**Report Type:** DA Access Report  
**Reference Number:** 19277  
**Client:** Designcorp  
**Site Address:** Arthur Neave Community Hall, Werrington, NSW

# ACCESS REPORT

This Access Compliance Report is to accompany a Development Application for the development proposed at Arthur Neave Community Hall, Werrington, NSW.

This development proposes Additions and Alterations to an Existing building for Community Centre. The development is within Penrith Council LGA.

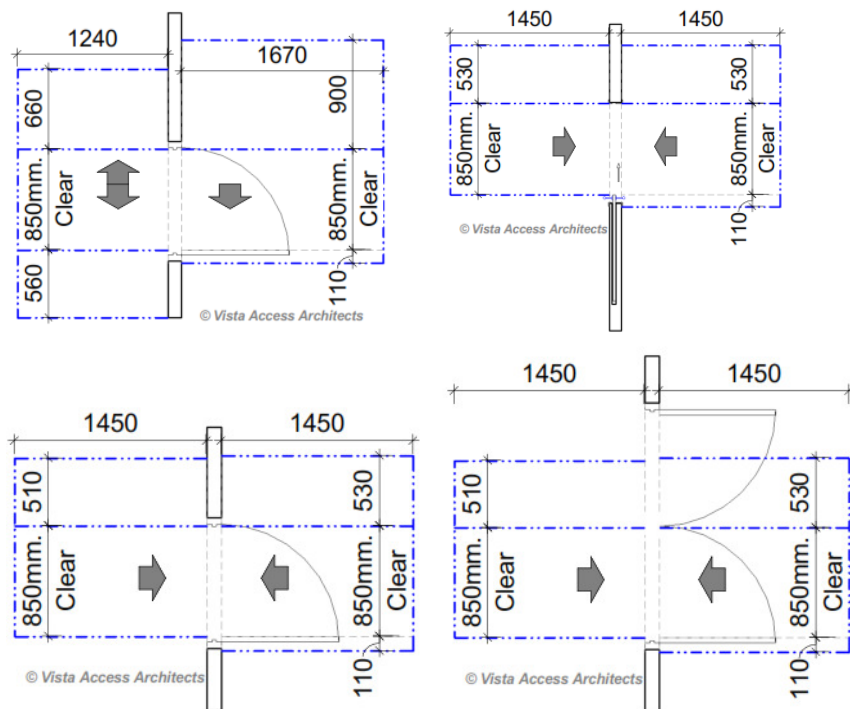
<p><b>Compliance Comments</b></p>	<p>Capable of compliance.</p> <p>As stated in the above requirements, APS only applies to,</p> <ul style="list-style-type: none"> <li>- New works,</li> <li>- Modified works and</li> <li>- Works within the 'affected part'</li> </ul> <p>In this development, the new works, modified works and works within the 'affected part' have been shown in the plan below with a red boundary.</p> <p>Details to be verified at CC stage of works.</p>

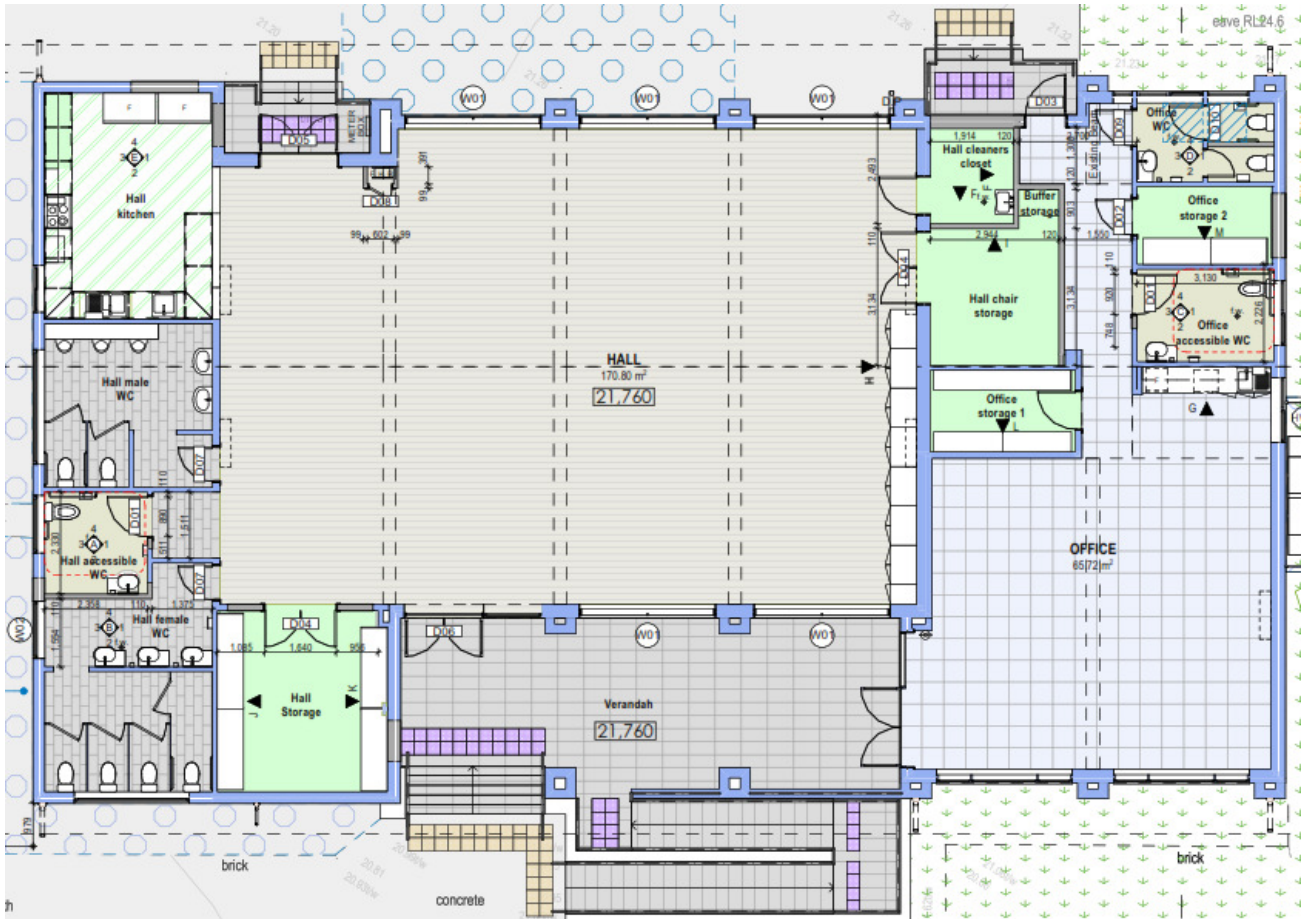
<b>Compliance Comments</b>	Complies. Unisex accessible LH transfer toilet has been provided near the bank of toilets Unisex accessible RH transfer toilet has been provided near office area.

<b>Requirement</b>	<b>Accessible unisex toilet are to be designed in accordance with AS1428.1-2009</b>
<b>Compliance Comments</b>	<p>Capable of compliance. Detailed features of the Accessible unisex toilet will be assessed with the requirements of AS1428.1-2009 at the CC stage of works.</p> <p><i>RH transfer toilet shown above</i>                      <i>LH transfer toilet shown above</i></p> <p><b>Note:</b> Location of door is indicative only.</p>
<b>Requirement</b>	<b>Ambulant use male / female toilets are to be provided if an additional toilet to the Accessible unisex toilet is provided</b>
<b>Compliance Comments</b>	<p>Complies The following Ambulant facilities have been provided 1 Unisex Ambulant use toilet for office staff use. Details to be verified at CC stage of works.</p>
<b>Requirement</b>	<b>Ambulant use toilets are to be designed in accordance with AS1428.1-2009</b>
<b>Compliance Comments</b>	<p>Capable of compliance. Detailed features of the Ambulant use toilets will be assessed with the requirements of AS1428.1 at the CC stage of works.</p>
